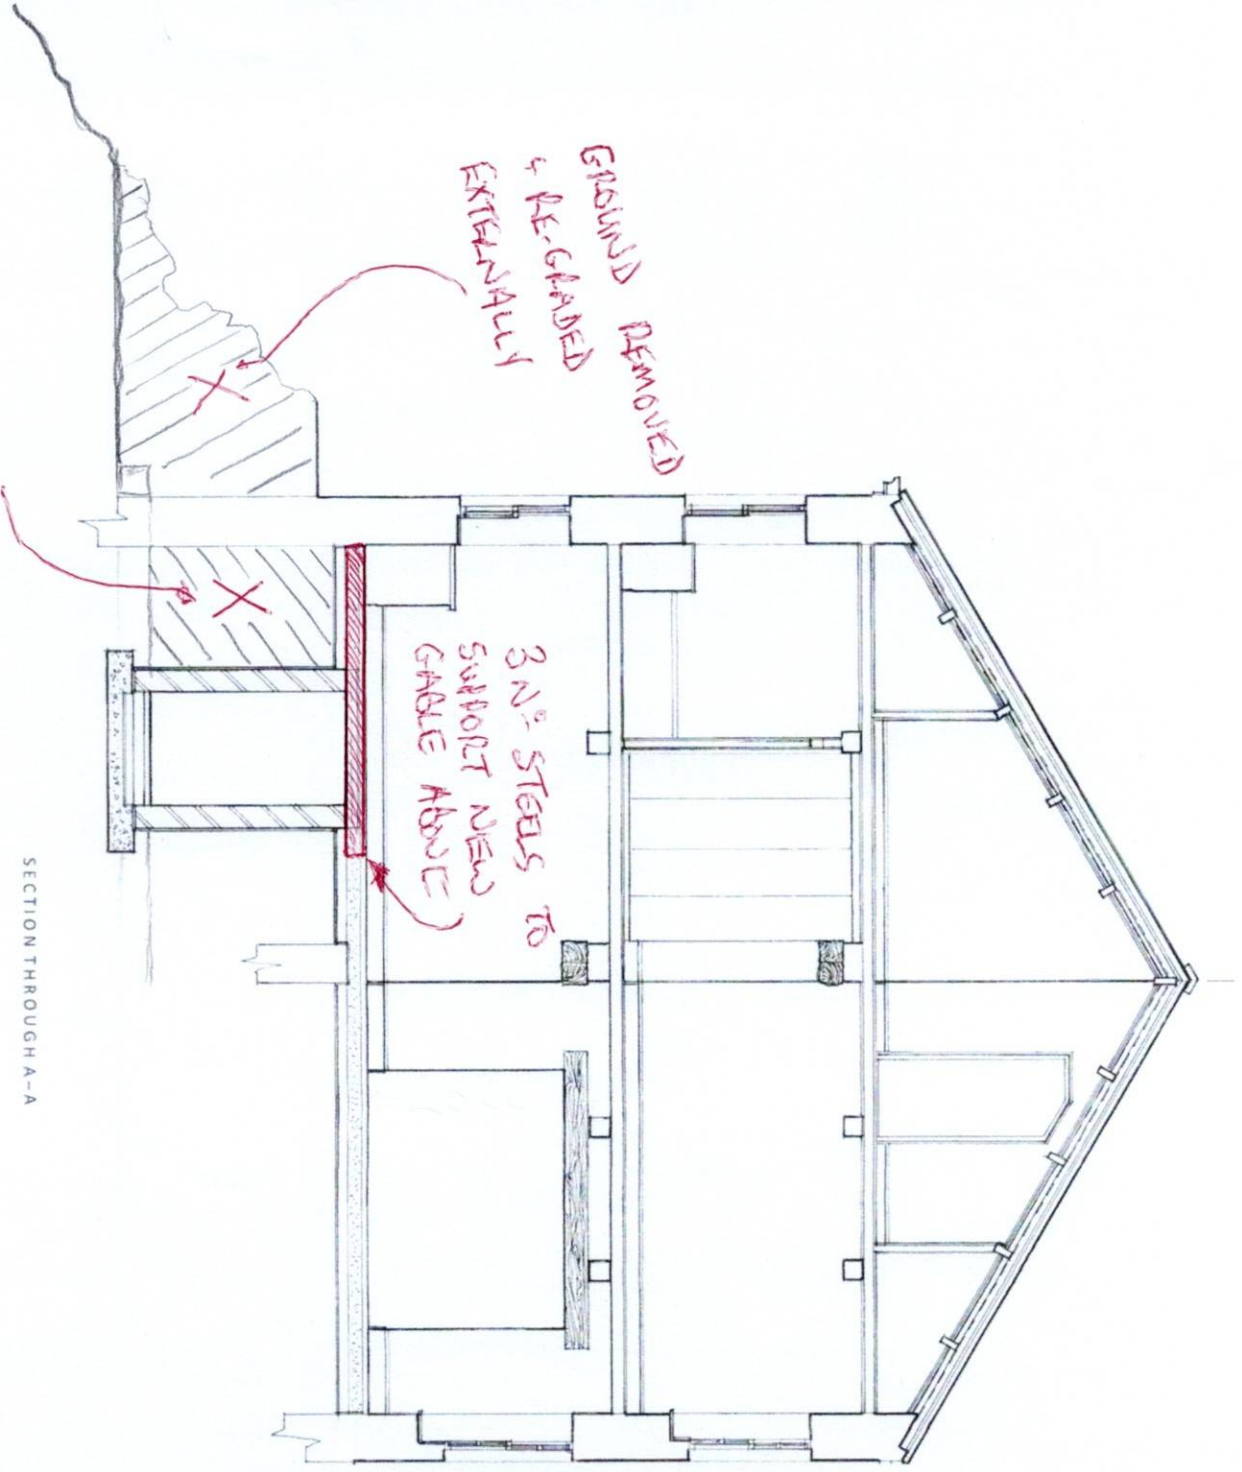
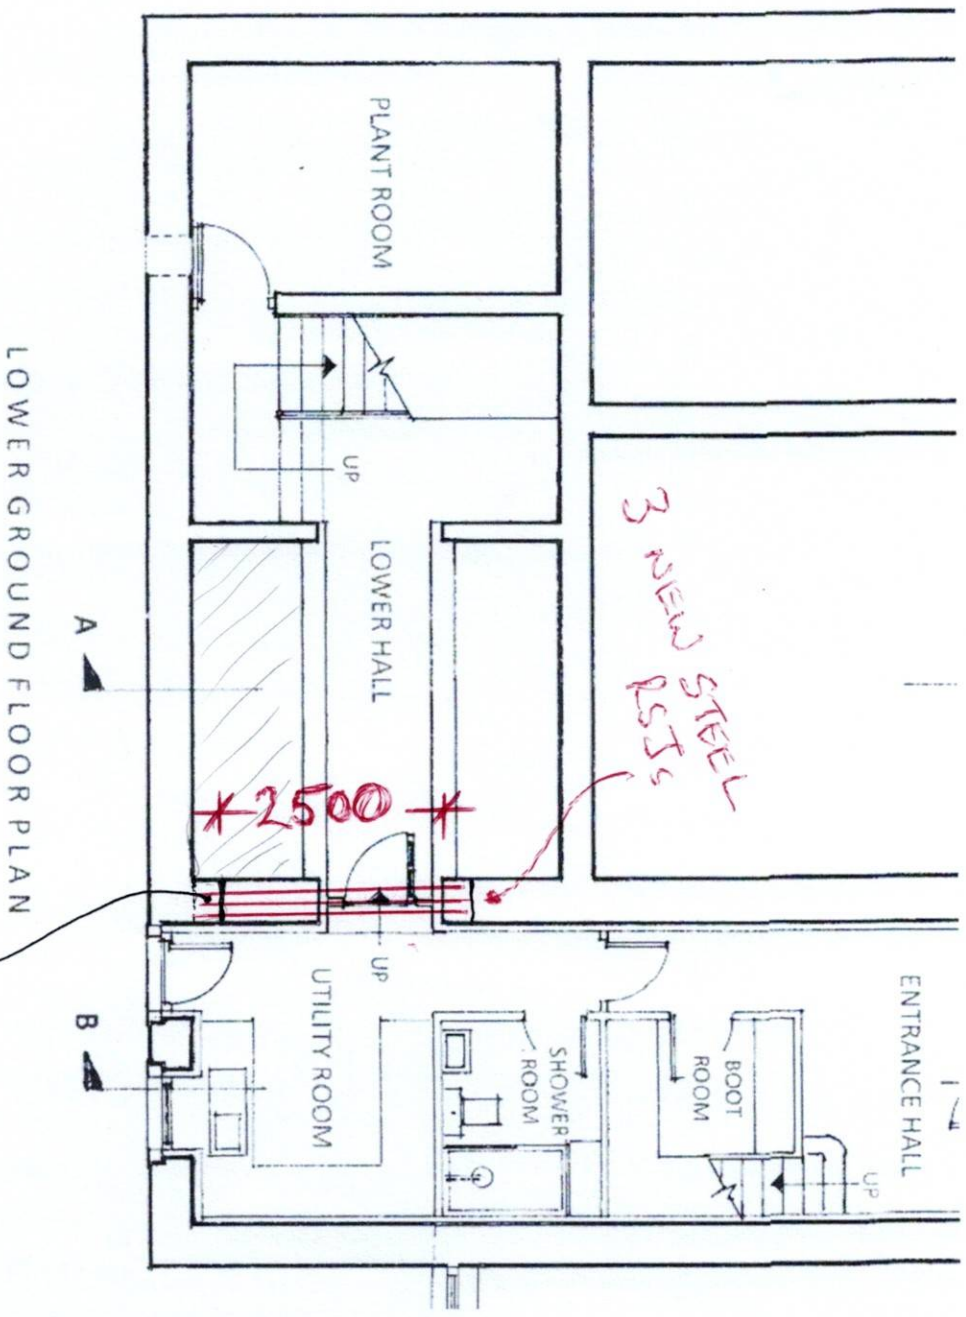
WITH GROUND REMOVED / REGRADED EXTERNALLY
WE COULD ALSO REMOVE THIS INTERNALLY

→ This would give us the option of moving the 'Tunnel' slightly LEFT or increasing the width of the 'Tunnel'?

EXISTING WALL
THICKNESS 620MM
**

NEW GABLE CONSTRUCTION

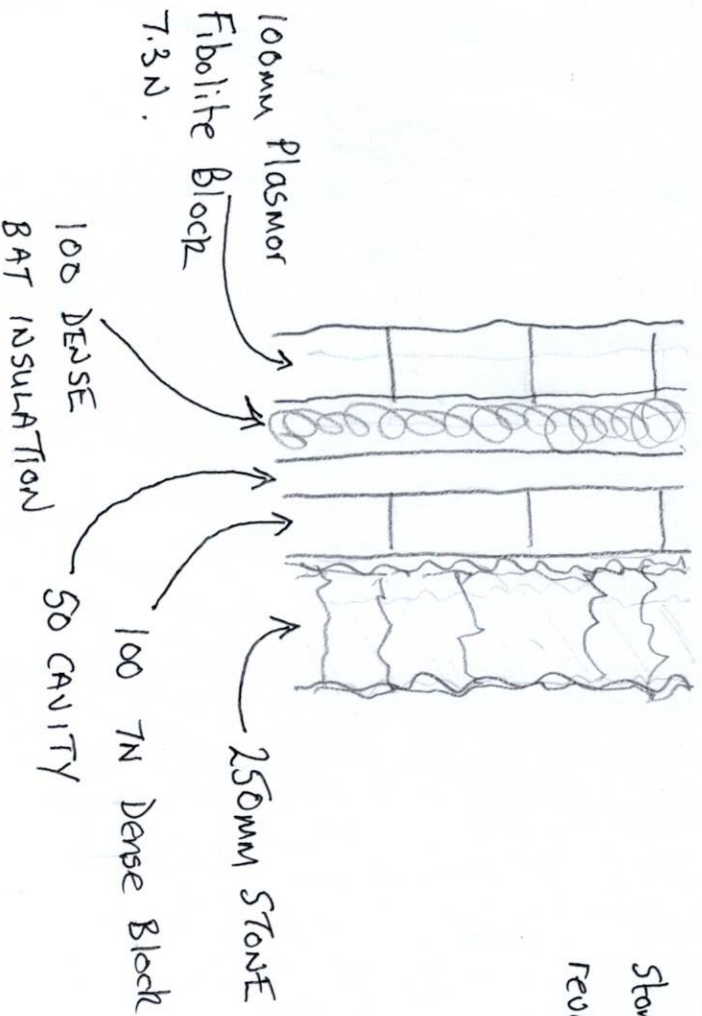
Retain a 'nib' and make good with new Stone Quoins to the reveal - both sides
